Project: 24.1095

**MCSC Lobby & General Improvements**

Written Addendum No.2

City of Kenora

•	SCALE:	511.5 11.0
	AS NOTED	FILE NO: <b>24.1095</b>
	DATE:	DRAWING #:
	MARCH 25, 2025	
	DRAWN BY:	A602r1
	JLS	HUUZII

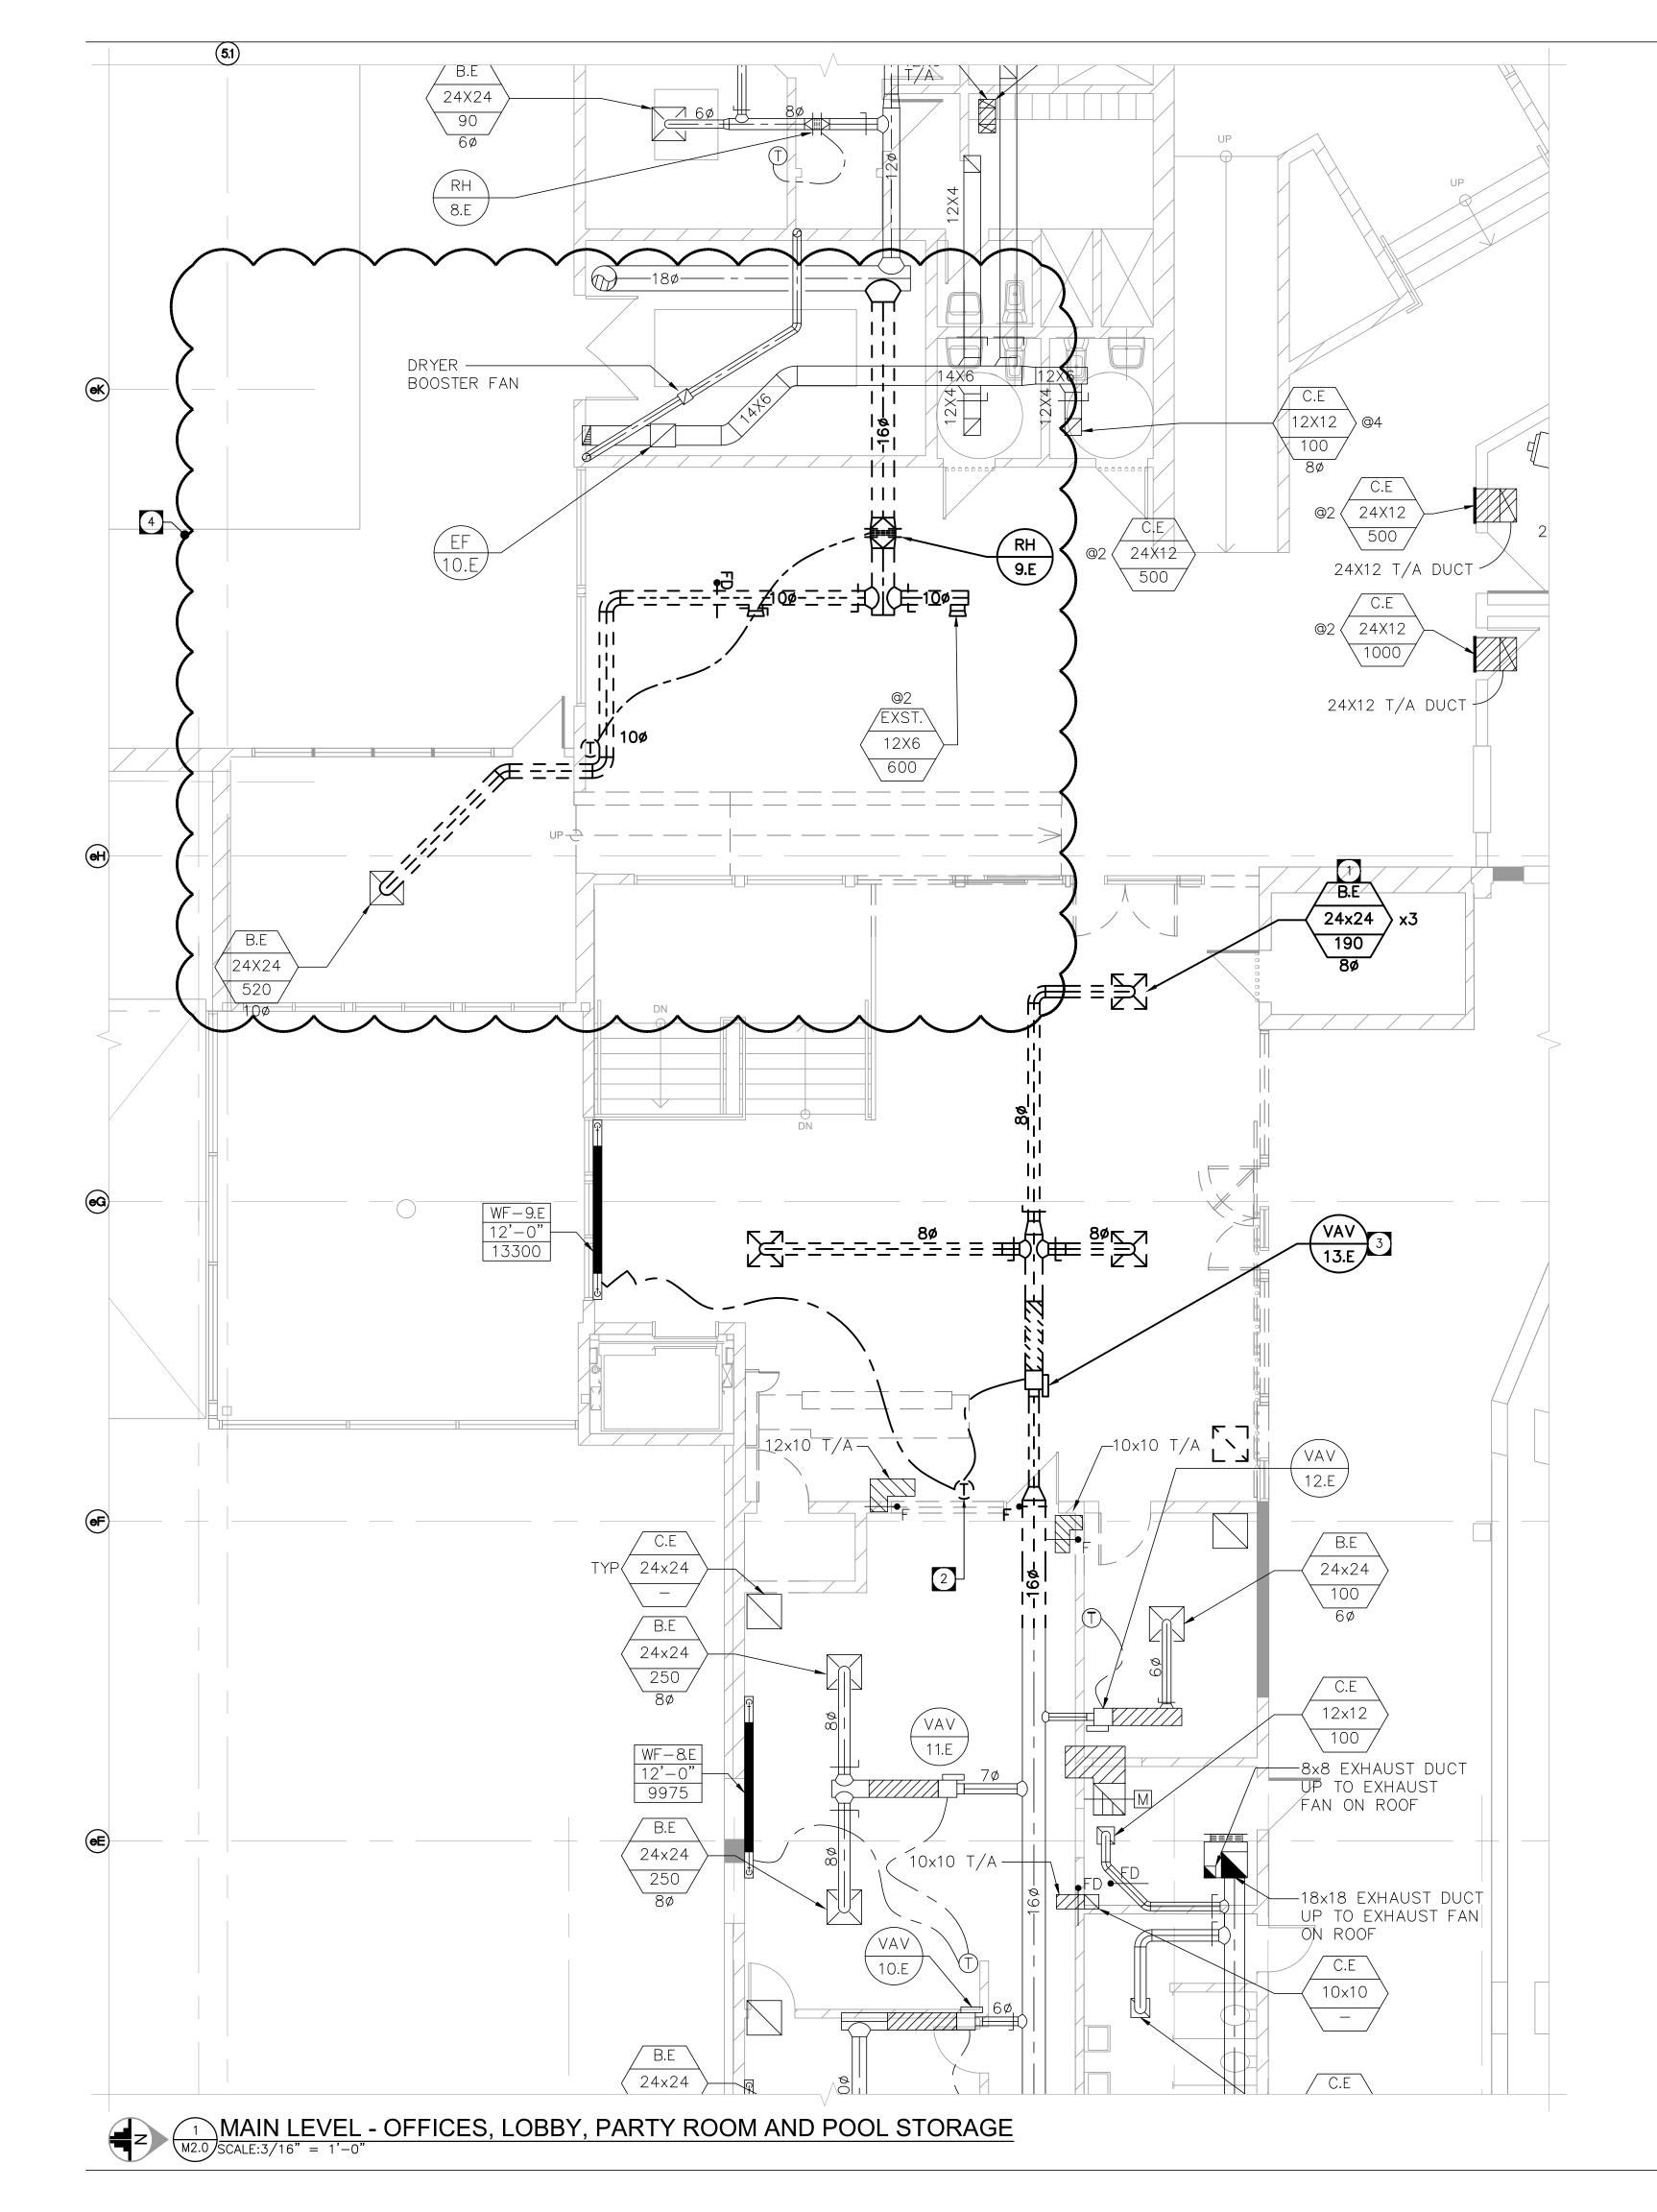
- 1. Separate Price #1 Elevation drawing revisions.
- 2. Additional notes to Graphic Wall at Washrooms

M3.1-R1

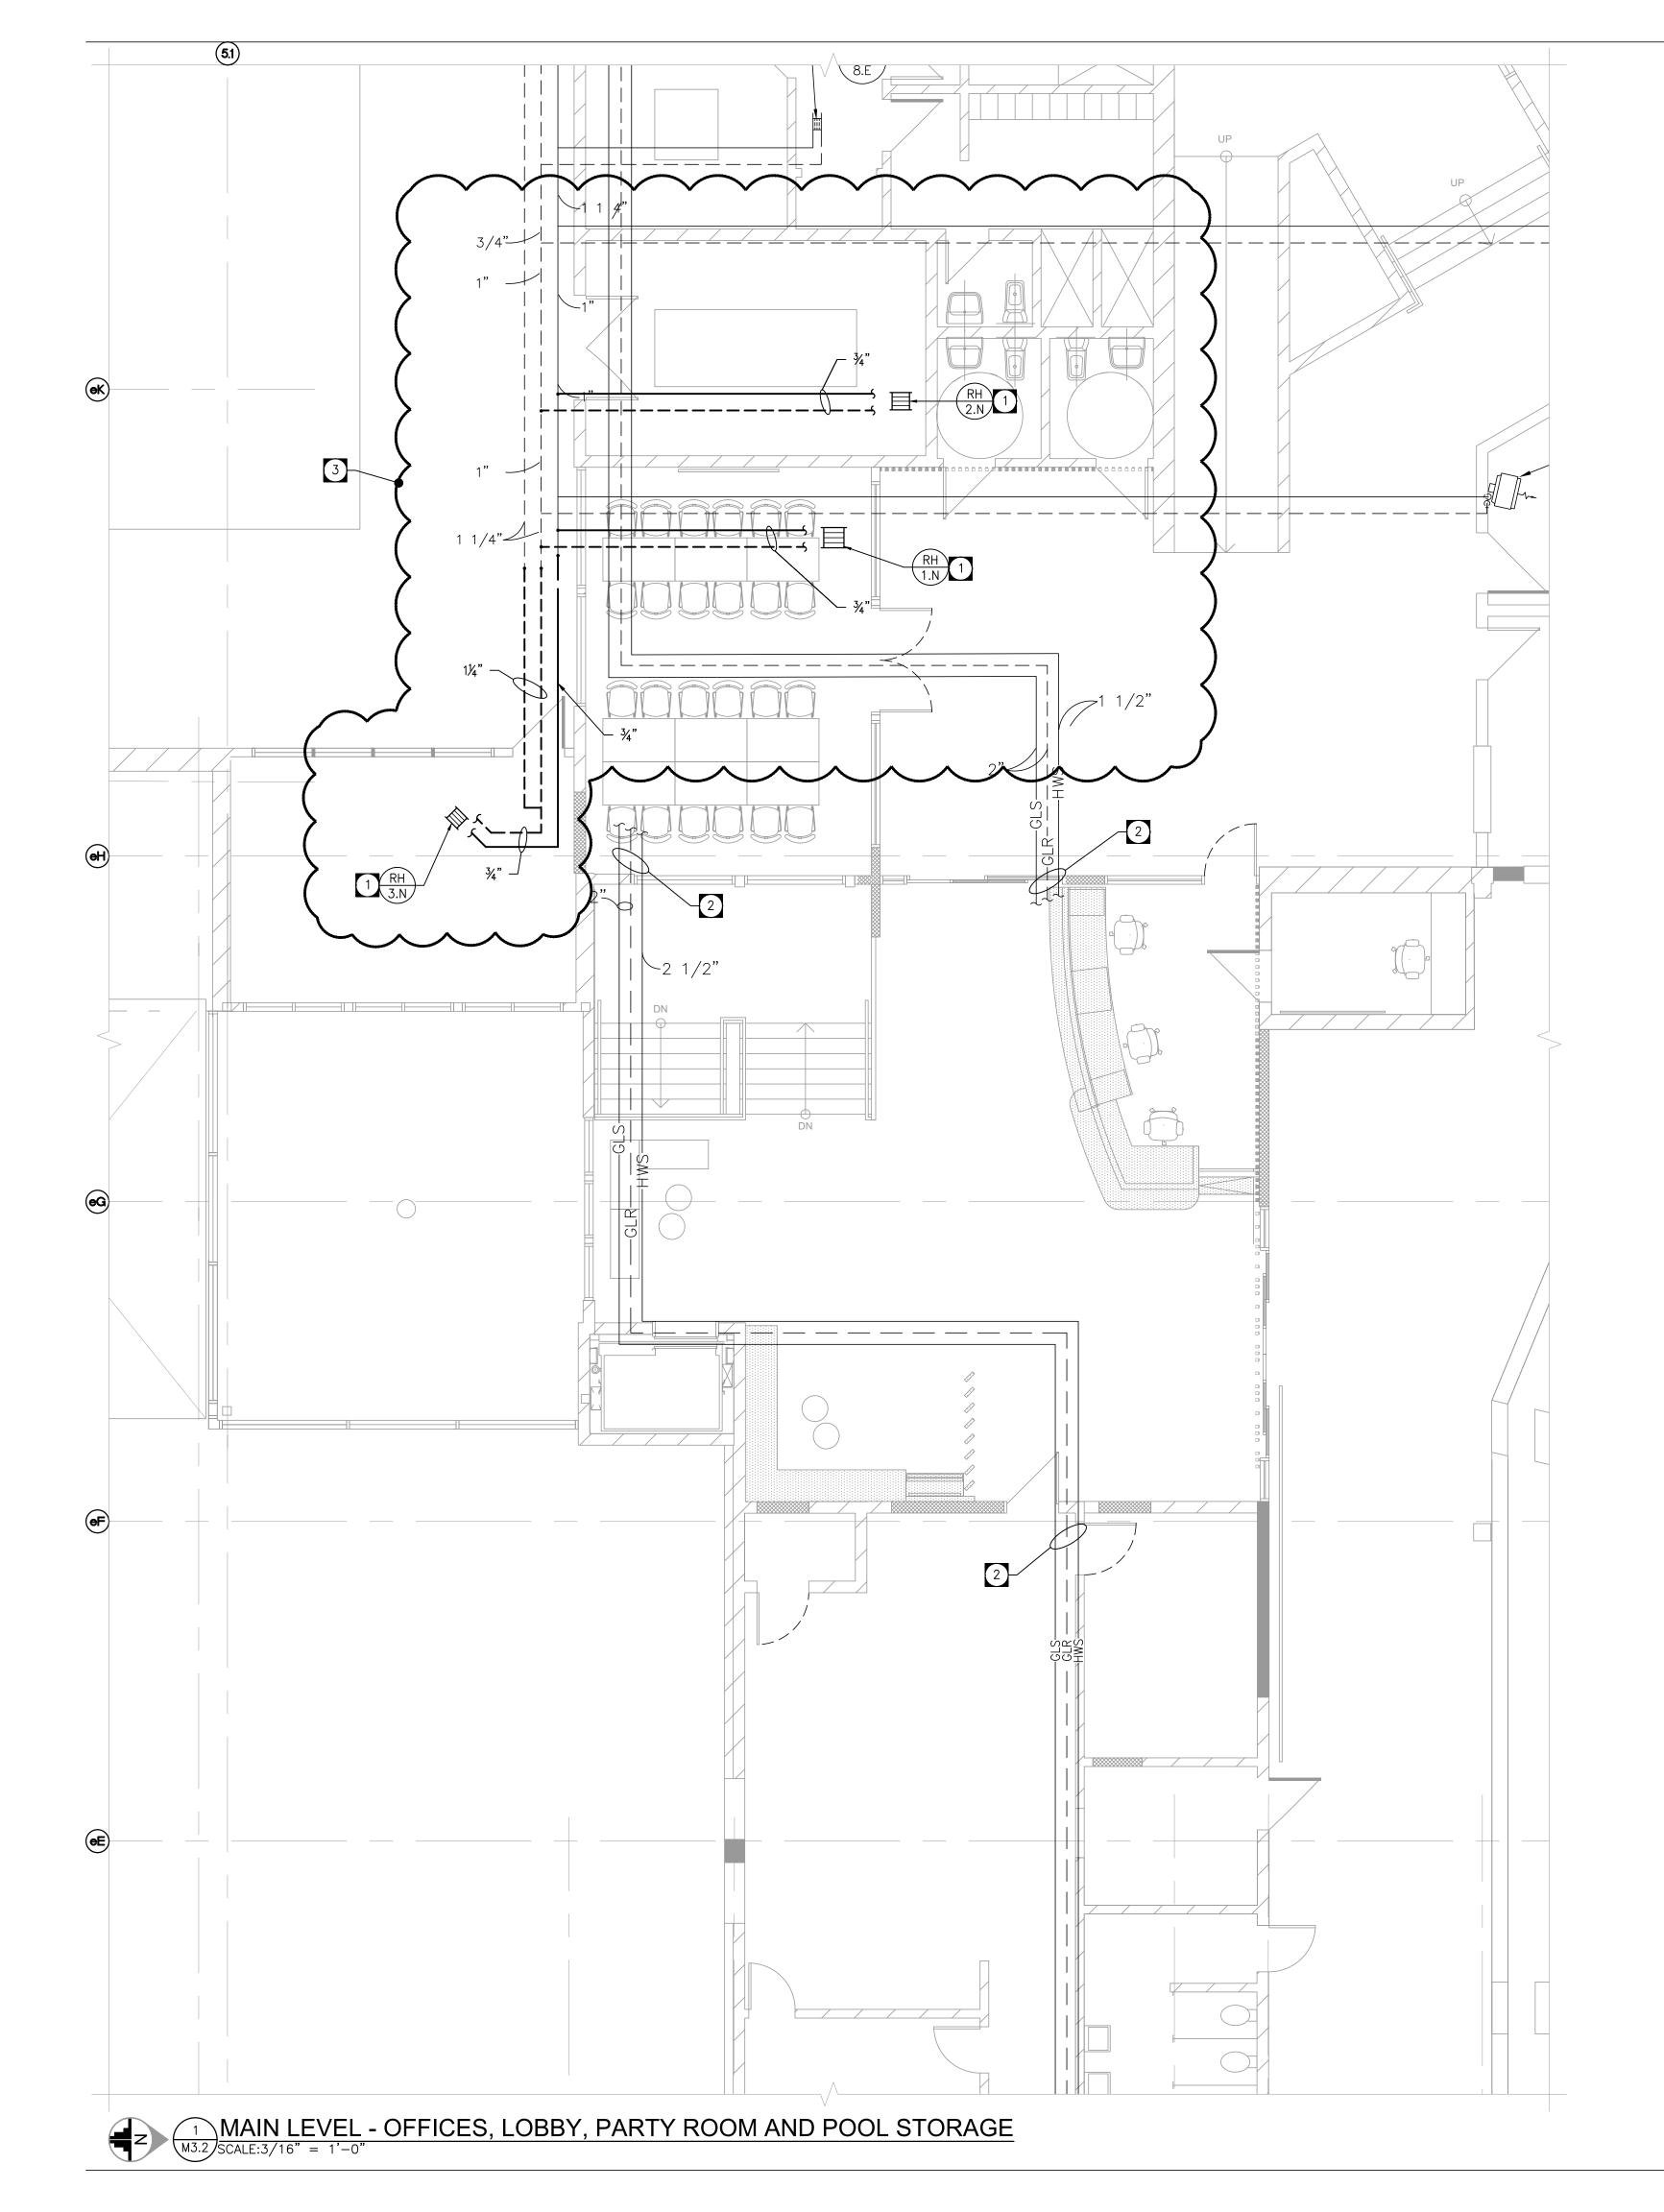
- .2 Relocate VAV box VAV-1.N to be above existing acoustic ceiling in the lobby. Modify new duct layout to suit location. Refer to clouded revisions on revised mechanical drawing.

SCALE:	FILE NO:
AS NOTED	24.1095
DATE:	DRAWING #:
2025-04-11	-
DRAWN BY:	
<b>CParaschiv</b>	M3.2-R1

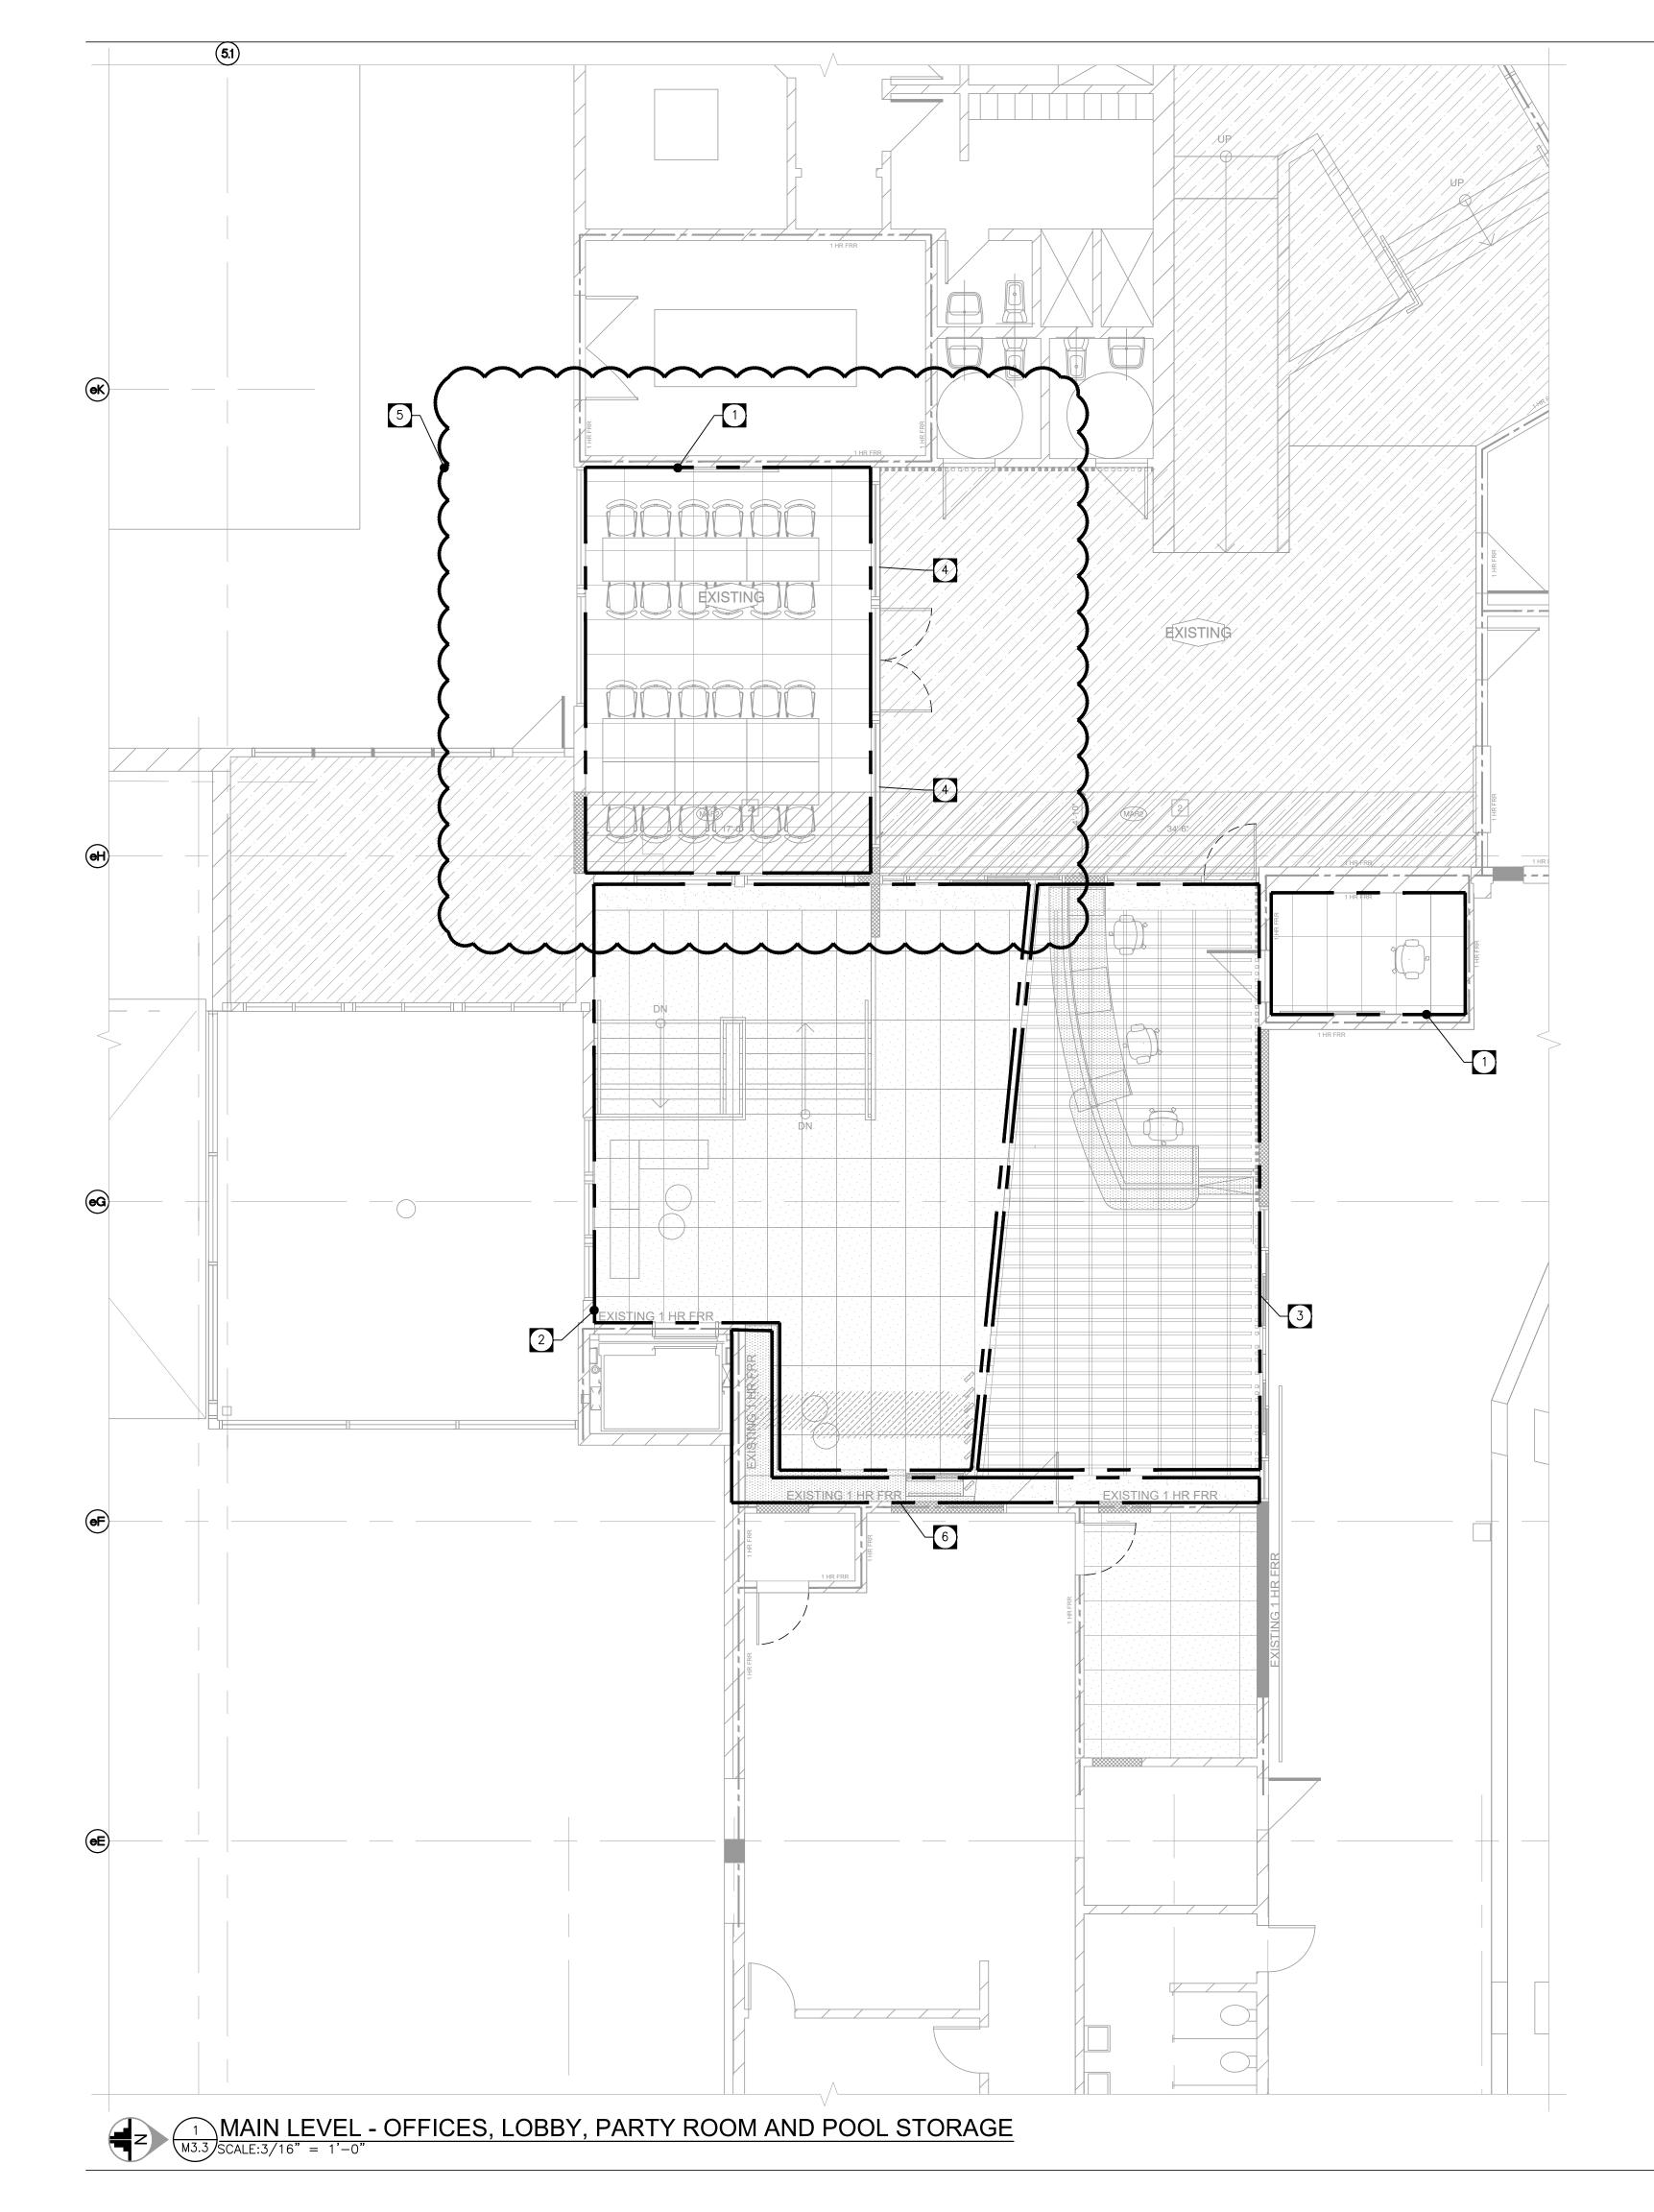
- 1.4 Refer to Drawing M3.2 Lobby and Multi-Purpose Room Hydronic Renovation Plan dated March 26, 2025.
  - .1 Relocate reheat coil RH-2.N to as per clouded revision on revised mechanical drawings.
